ADDENDUM 3

PROJECT NAME: Huebner Creek to Medical Center Trail and Park Phase 1 (Floyd Curl to Eckert)

DATE: 4/28/2025

PROJECT NO: 23-04004

PARKS & RECREATION			
HUEBNER CREEK GREENWAY-VOL. 1 BABCOCK RD TO ECKHERT RD BENT 2 DETAILS					
100 % SUBMITTAL		PROJECT NO.: C-1628.06		DATE: 03/25/2025	
DRWN. BY: SS		DSGN. BY: LDW		CHKD. BY: LDW	
				SHEET NO.: C807

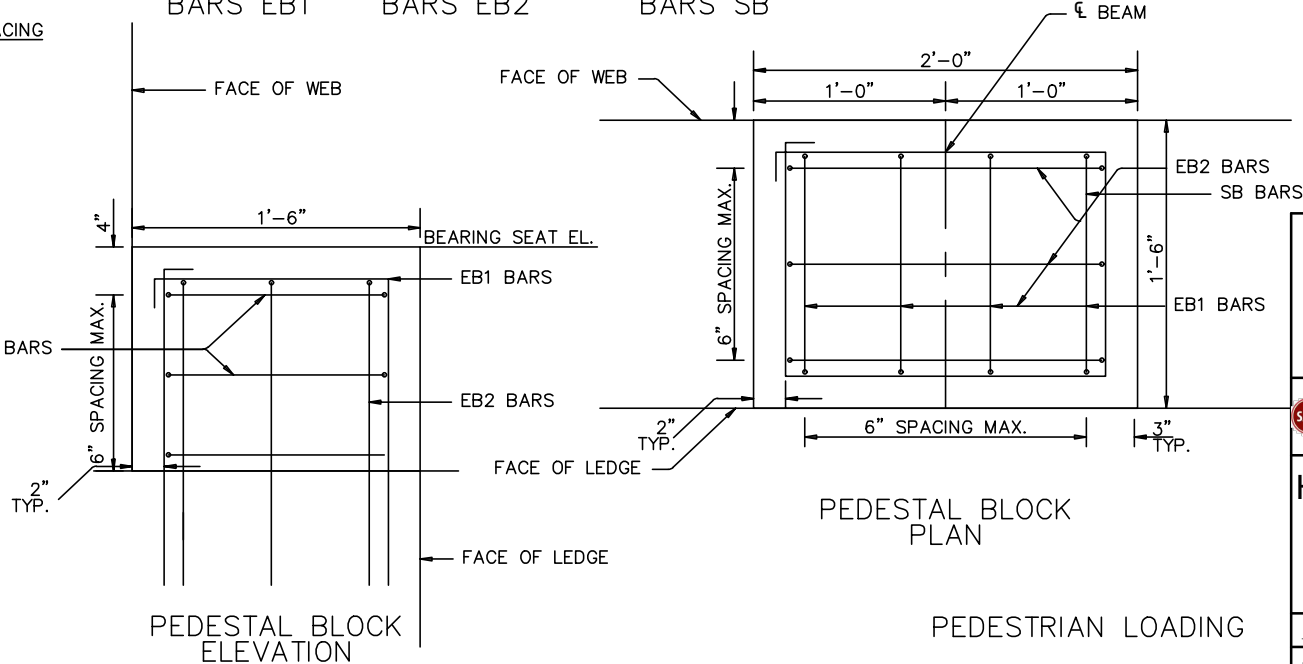
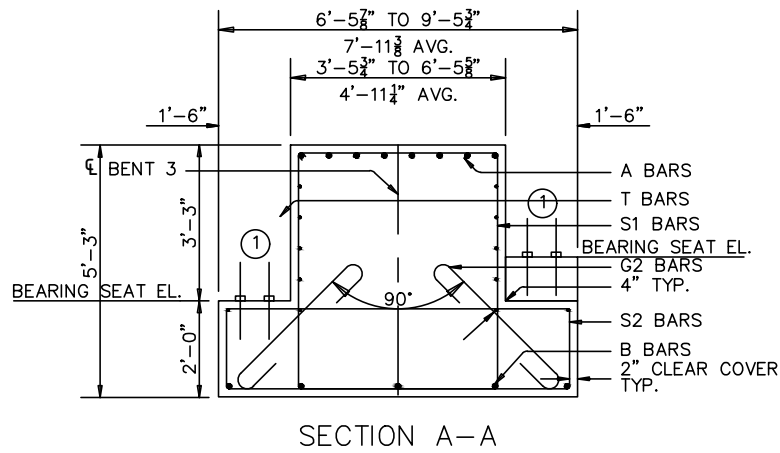
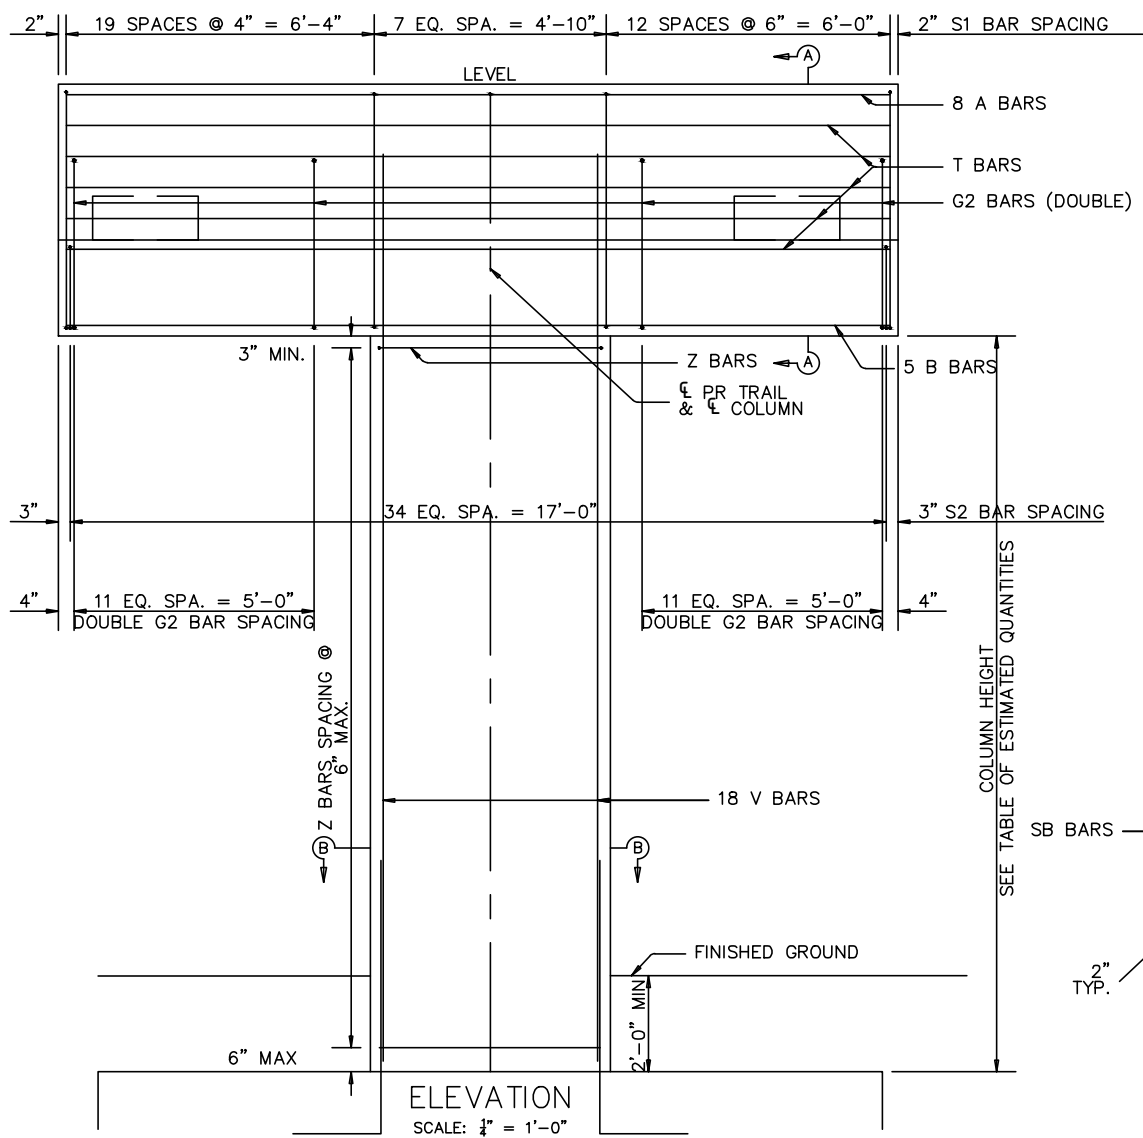
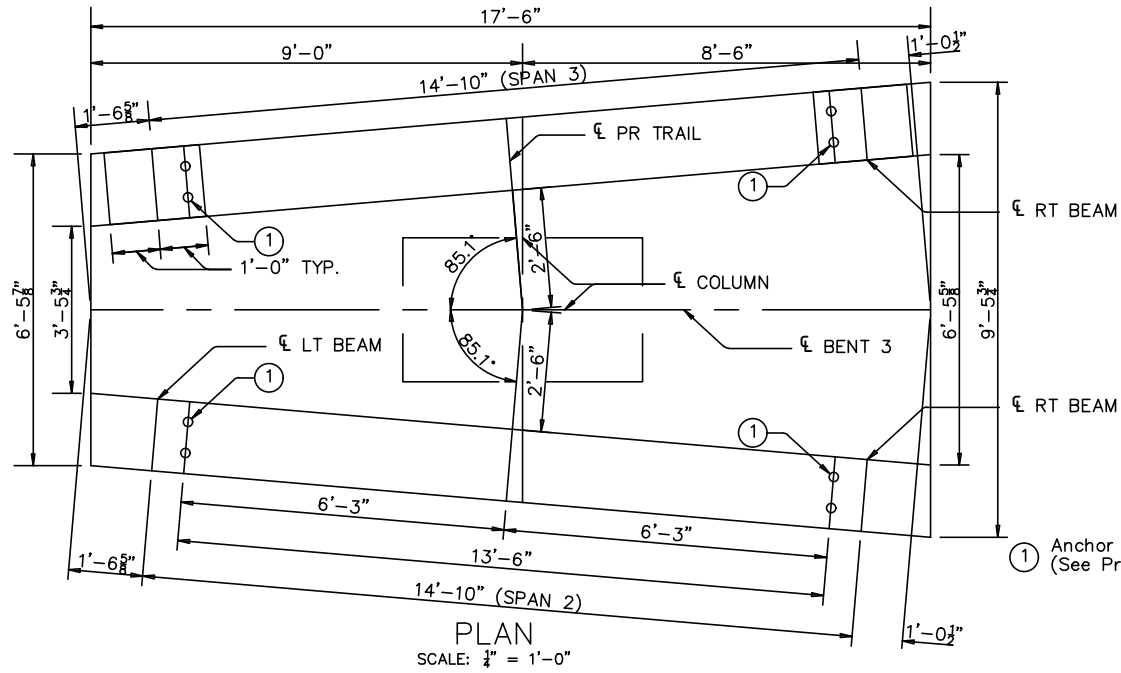
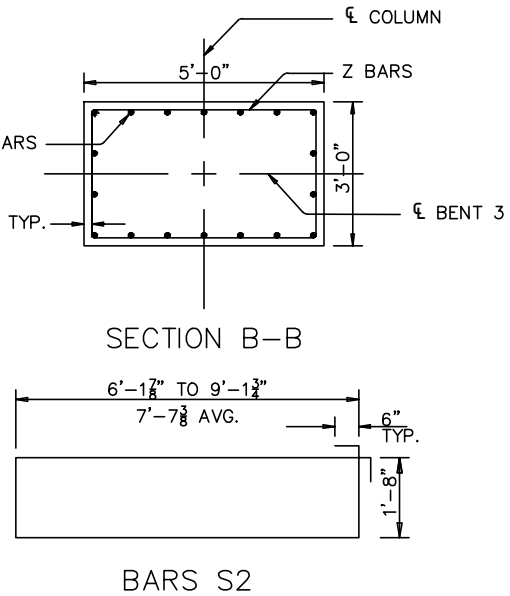
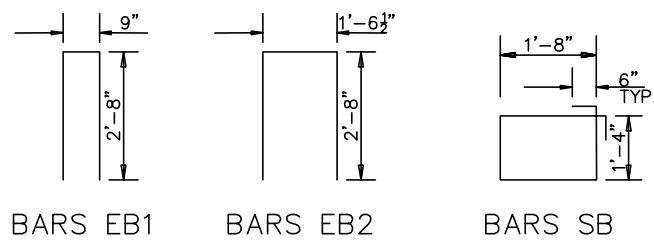
C807 – Updated Bent 2 Details

HUEBNER CREEK GREENWAY-VOL. 1
BABCOCK RD TO ECKHERT RD
BENT 3 DETAILS

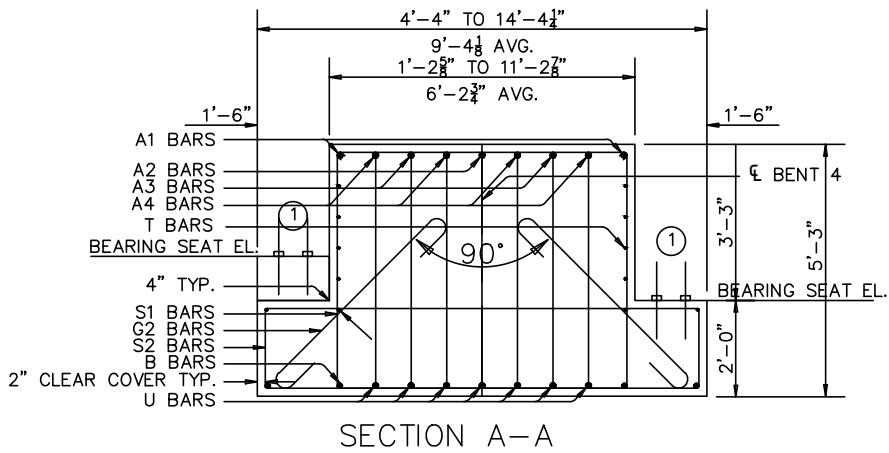
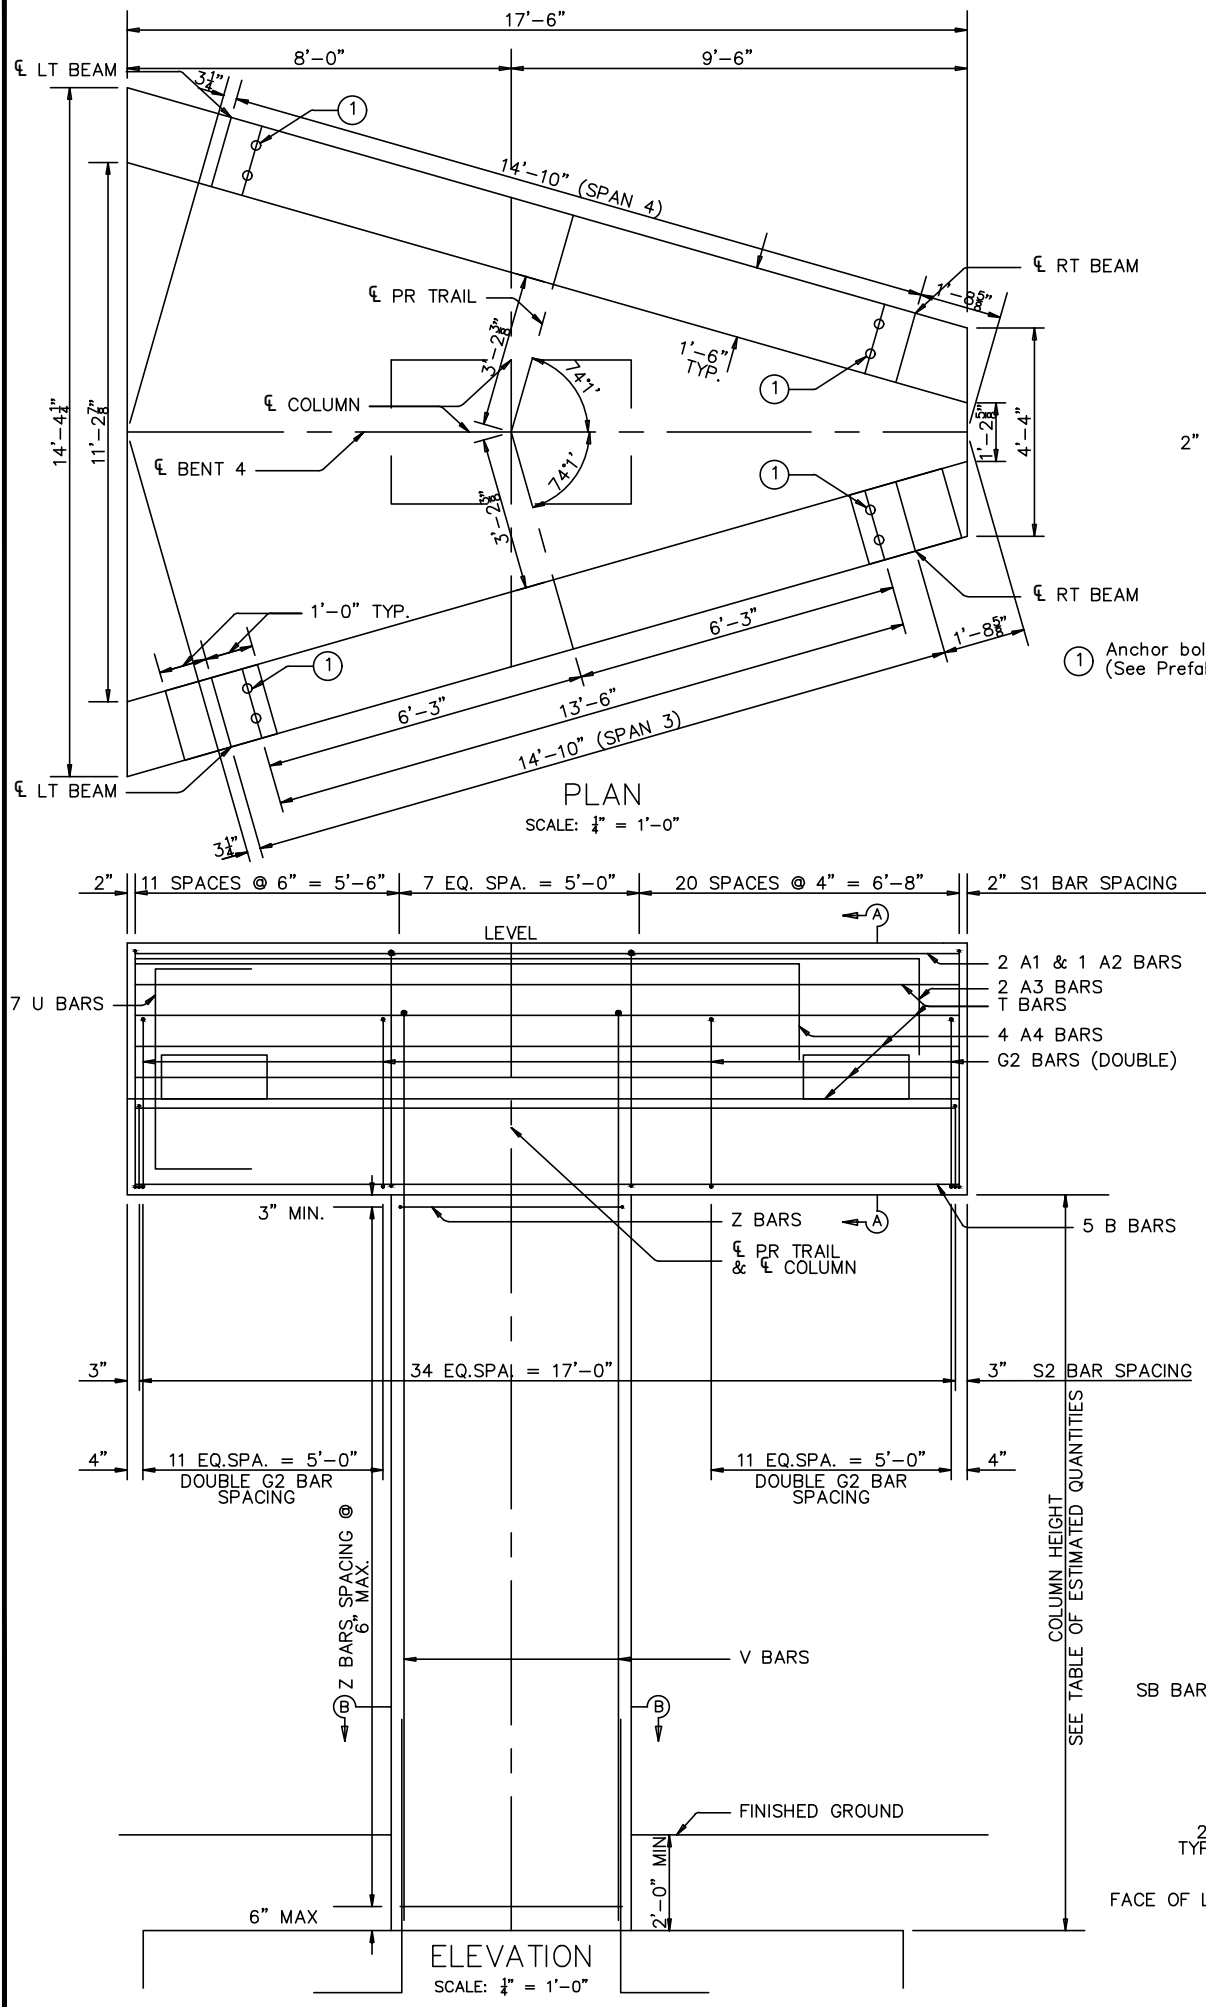
C808 – Updated Bent 3 Details

HUEBNER CREEK GREENWAY-VOL. 1
BABCOCK RD TO ECKHART RD
BENT 4 DETAILS

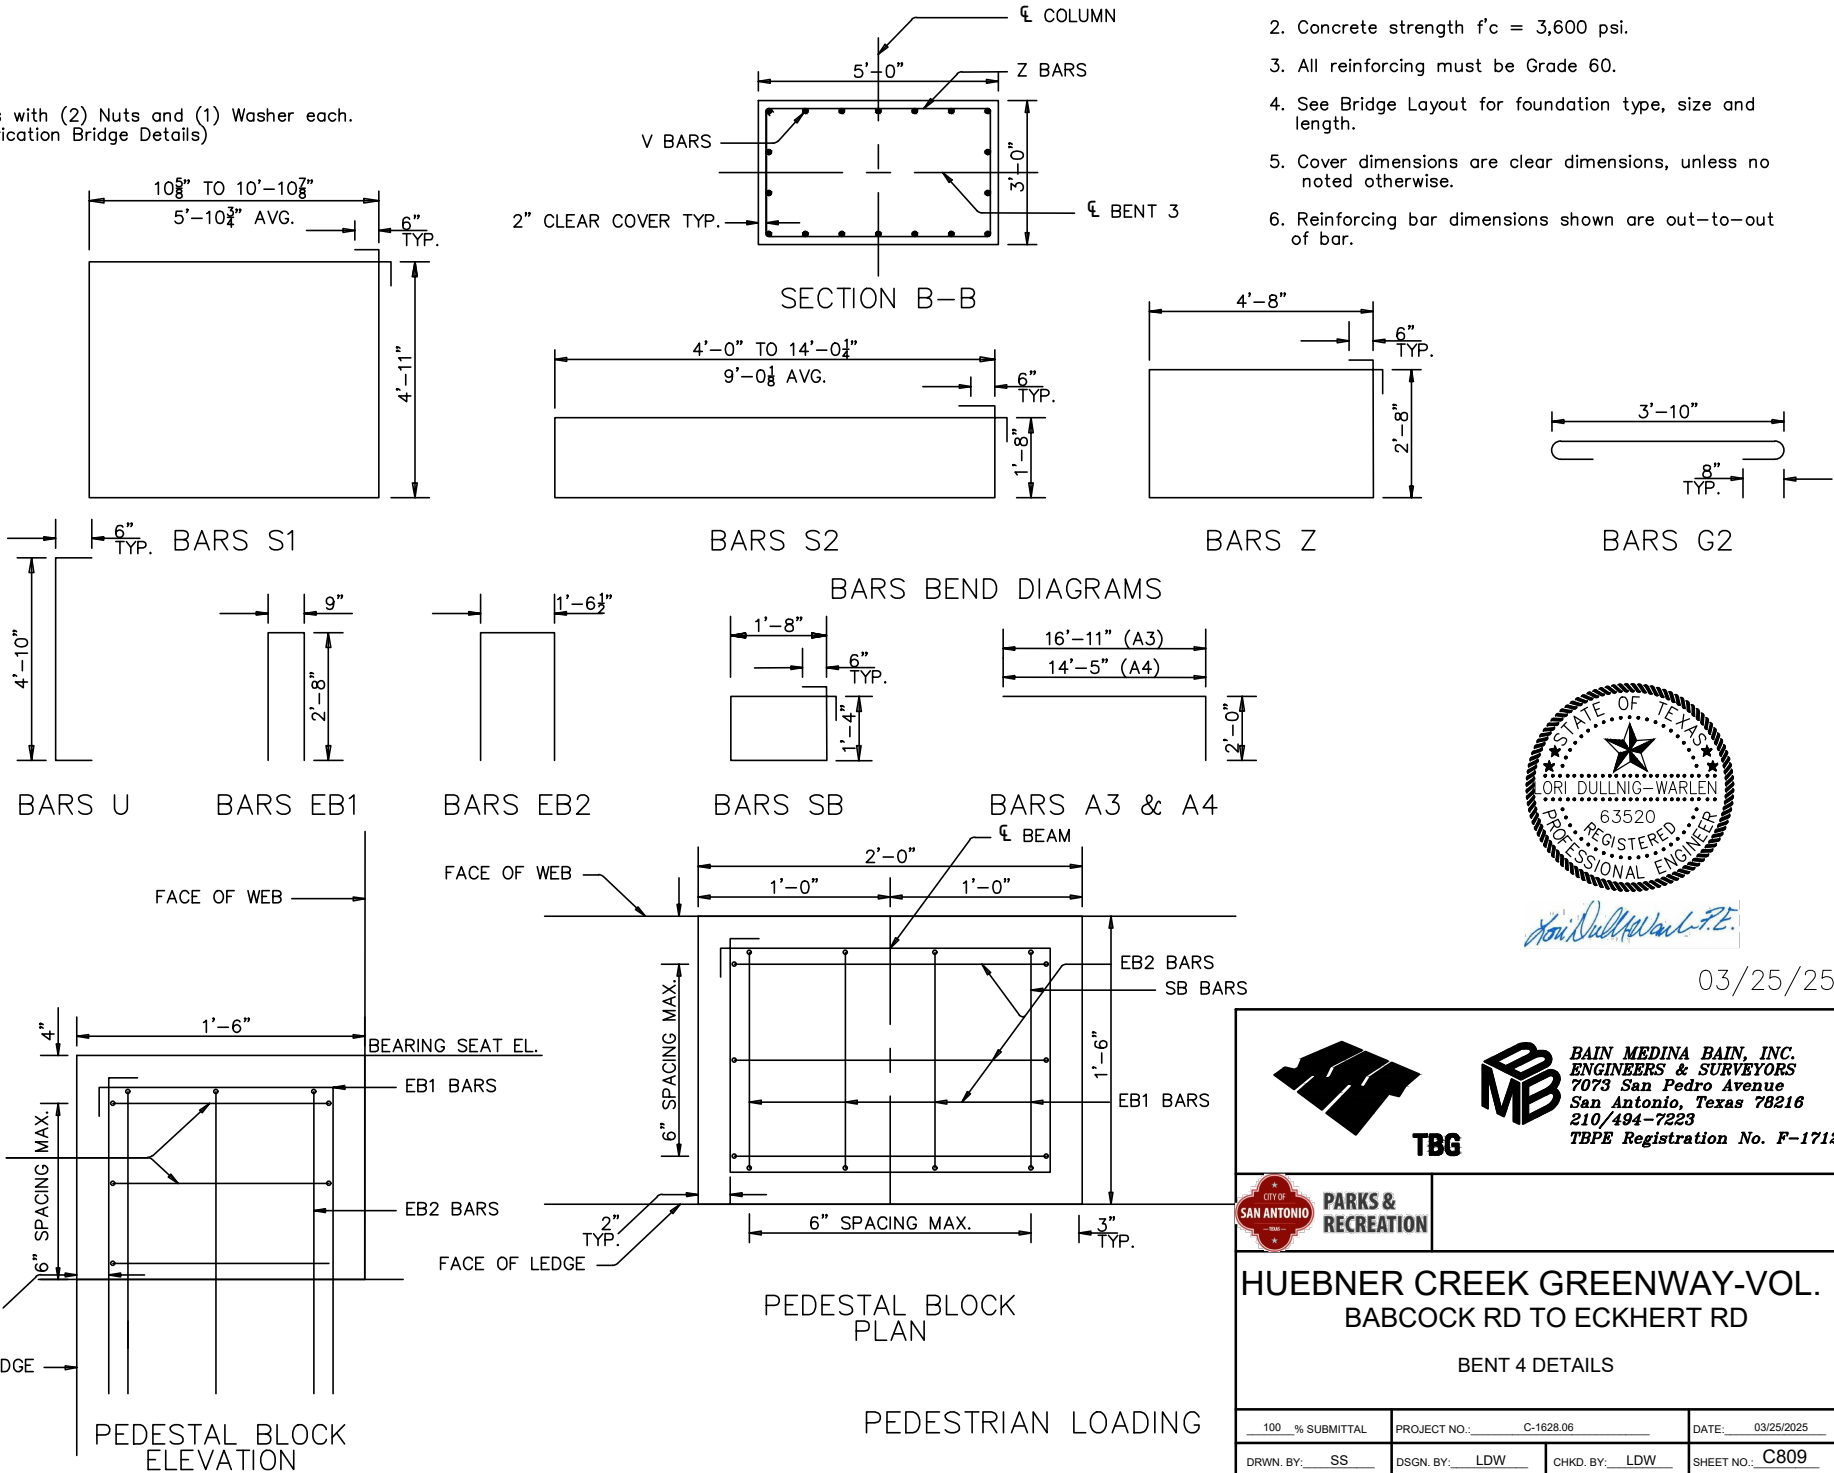
C809 – Updated Bent 4 Details
